Metropolitan Planning Commission

Staff Reports

March 10, 2011

| Project Name | Implementing Complete Streets: Major and Collector Street Plan of Metropolitan Nashville, A Component of Mobility 2030 |

APPLICANT REQUEST Off-site improvements for the College of Law Building

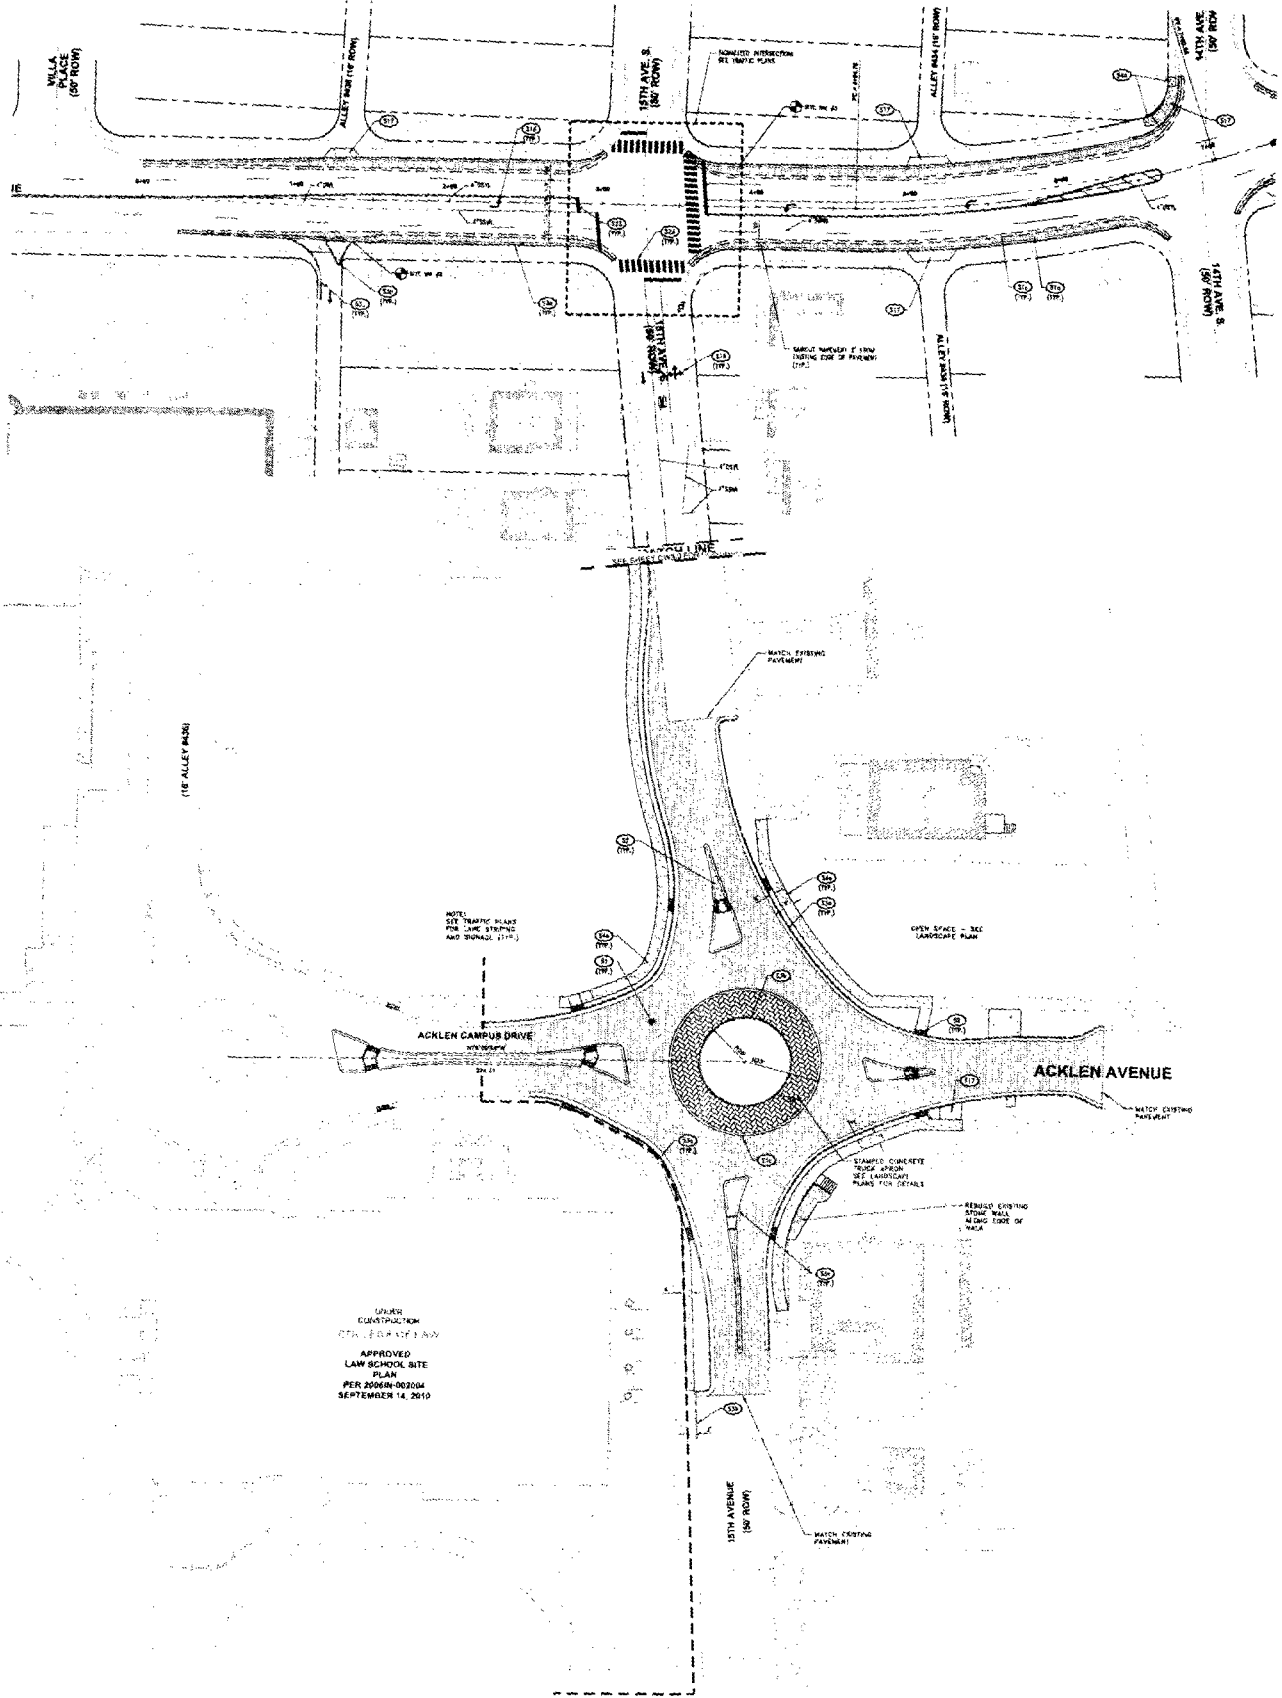
- 2) Sheet C3.0 – Demolition Plan shows a pole line along the south side of Acklen Ave to be removed. Pole line has been labeled as “NES to remove”. This pole line belongs to AT&T and removal must be coordinated with them.

- 3) Sheet CW3.0 – Demolition Plan shows NES to remove a pole at the corner of 15th Ave and Wedgewood Ave. If this pole is to be removed, overhead power will not be available on 15th Ave from Wedgewood to Acklen. Customer will be responsible for any relocation and easement costs required to keep electrical service to the customers along 15th Ave from Wedgewood to Acklen. Additionally, if power is removed from 15th Ave, NES does not have the ability to continue to provide temporary power to the construction offices for Belmont University located at the corner of Acklen and 15th Ave.

- Sheet C4.0 Extend the proposed DSYL pavement marking on the north approach of the roundabout from the intersection of Wedgewood.
- Sheet CW3.0
 - (1) Remove the shared LT-THRU-RT pavement markings from the northbound right hand lane on 15th Avenue at Wedgewood and replace with THRU-RT markings.
 - (2) Label the SSWL lane marking for the northbound approach on 15th Avenue at Wedgewood
 - (3) Modify the traffic signal plan to accommodate the pavement marking changes on 15th Avenue at Wedgewood. Submit signal plan to Chip Knauf at MPW for review.
